Technical Service Bulletin

94 Moisture accumulation in headlamps

94 12 91 2028277/3 October 24, 2012. Supersedes Technical Service Bulletin Group 94 number 12-68 dated March 1, 2012 for reasons listed below.

Model(s)	Year	VIN Range	Vehicle-Specific Equipment
Q7	2010-2011	000001-999999	Not Applicable
	2012	000001-004736

Figure 2. Ventilation Hose with Integrated Filter

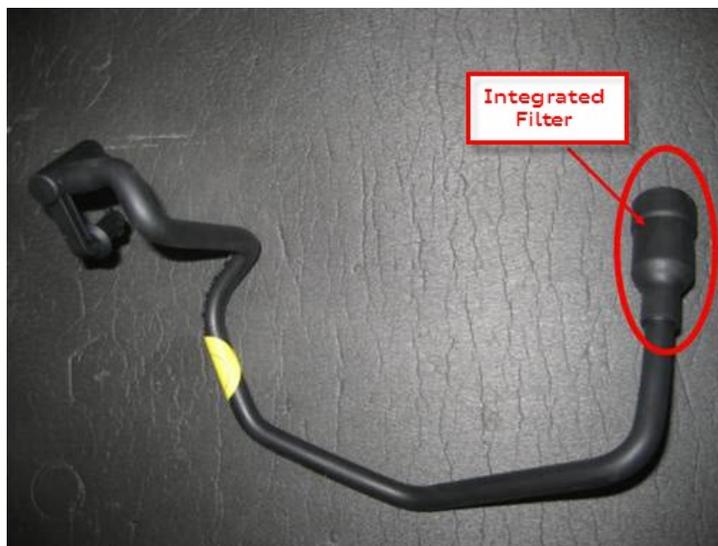
2. Replace the headlamp ventilation hose for each headlamp with the new part number to help reduce any further humidity ingress into the headlamps (see Part information table below).

The modified ventilation hose can be recognized by the integrated filter as seen in Figure 2.
